Accessibility Audit Report

Birtley House Independent School

Fawkham Road
West Kingsdown
Sevenoaks
TN15 6AY

Access Consultant: S Malton
Date: 30th October 2025

13.1

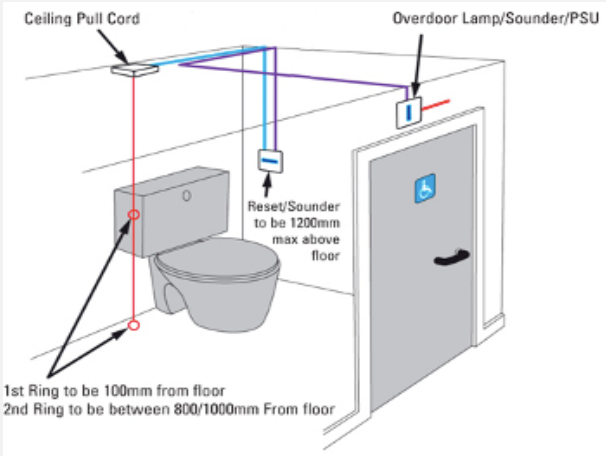
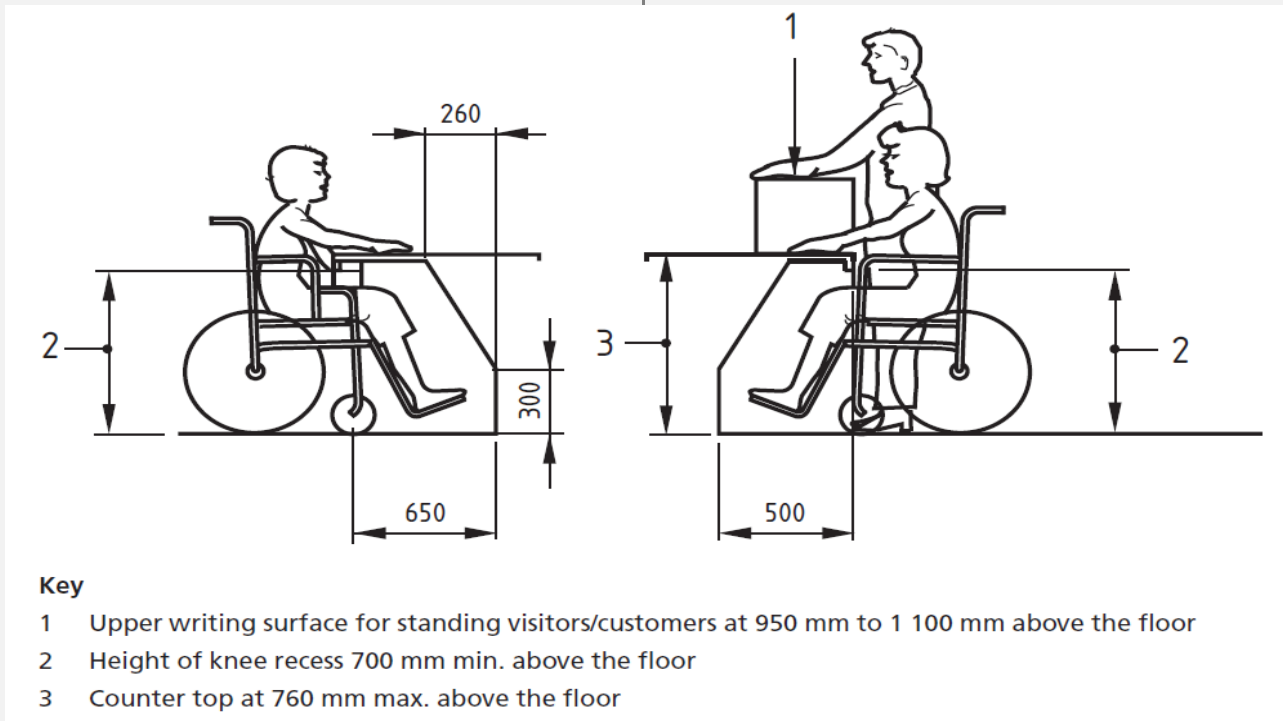
The accessible WC facilities were measured as follows: Mobile building: 3001mm by 1393mm Main building: 3628mm by 1771mm The toilet pan remains centrally located within the mobile building compartment.	As per previous reports, this is deemed reasonable to retain if people are aware of the alternative WC facility within the main building and if level access to this facility is provided. Should a member of staff or student have a specific requirement, the layout should be reviewed and altered to achieve the correct Part M positioning to allow a side wheelchair transfer.

Height of drop-down rails to be the same as the other horizontal grab rails

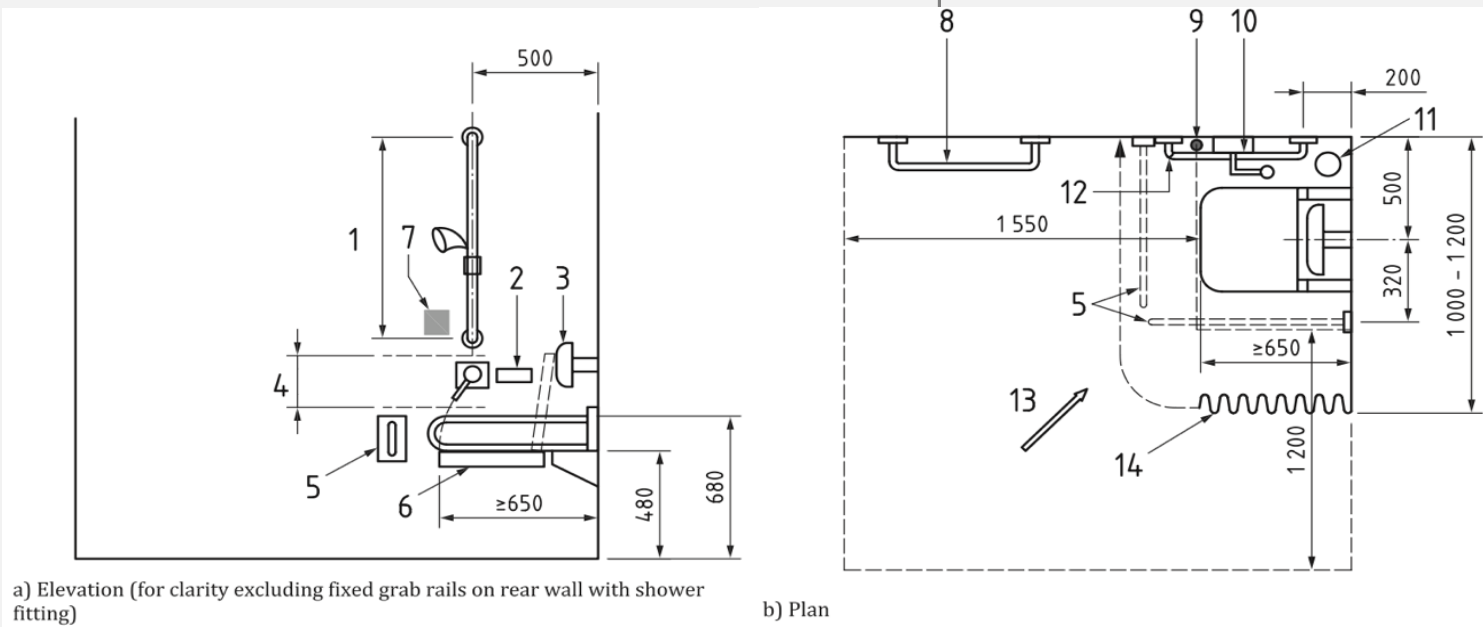
6.3	The sign in screen is positioned marginally high from ground floor level. The reception desk is at a height of 1165mm, which may not be suitable for all staff members and/or visitors. The auditor was informed of plans to reposition the desk to provide more space for people to manoeuvre in the reception area.	It is understood that level access via the main entrance is not possible; however, the reception should be designed to accommodate all potential users with at least one section of the counter with its surface no higher than 760mm.	M
	 Key 1 Upper writing surface for standing visitors/customers at 950 mm to 1 100 mm above the floor 2 Height of knee recess 700 mm min. above the floor 3 Counter top at 760 mm max. above the floor

12.8

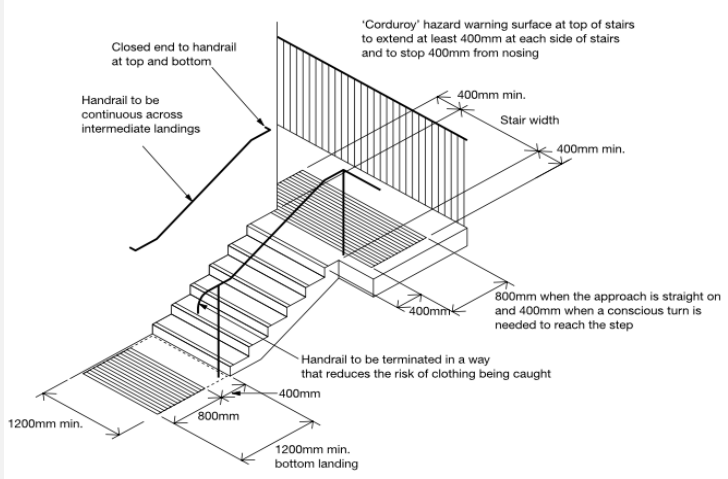
12.4	Thumb style locks are available on the WC compartment doors, which may not be suitable for people with limited dexterity in their wrists.	Door locks and door-furniture should be easy to operate using a 'closed-fist', limited dexterity and/or minimal force. Bold action and sliding locks are preferred and thumb-turn locks should be avoided.	M
	A level access shower remains available in the Rabbit classroom building; however, the raised threshold to contain water could be a barrier for wheelchair users. The controls for this shower are high from ffl. The shower facility on the first floor remains decommissioned since the previous audit.	Proportionate to demand, and should level access be gained into the building where the shower facility is situated, it is recommended to refurbish the shower facility to be accessible for all potential users. BS8300 to be referred to for the layout.

- Key**
- 1 Vertical rod to carry a detachable shower head, adjustable within a range 1 050 mm to 1 850 mm above the floor
 - 2 Soap tray
 - 3 Back rest
 - 4 Height range for shower controls 750 mm to 1 000 mm above the floor
 - 5 Drop-down support rails on side and rear walls
 - 6 Tip-up shower seat
 - 7 Alarm reset button
 - 8 Towel rail
 - 9 Alarm pull cord
 - 10 Horizontal grab rail
 - 11 Floor drain
 - 12 Vertical grab rail
 - 13 Fall to floor drain not steeper than 1:50
 - 14 Shower curtain
 - 15 Tall mirror
 - 16 Two clothes hooks, one at 1 400 mm and the other at 1 050 mm above the floor
 - 17 Additional optional tip-up seat for users when drying (mainly for ambulant users) (see e.g. Figure 30)
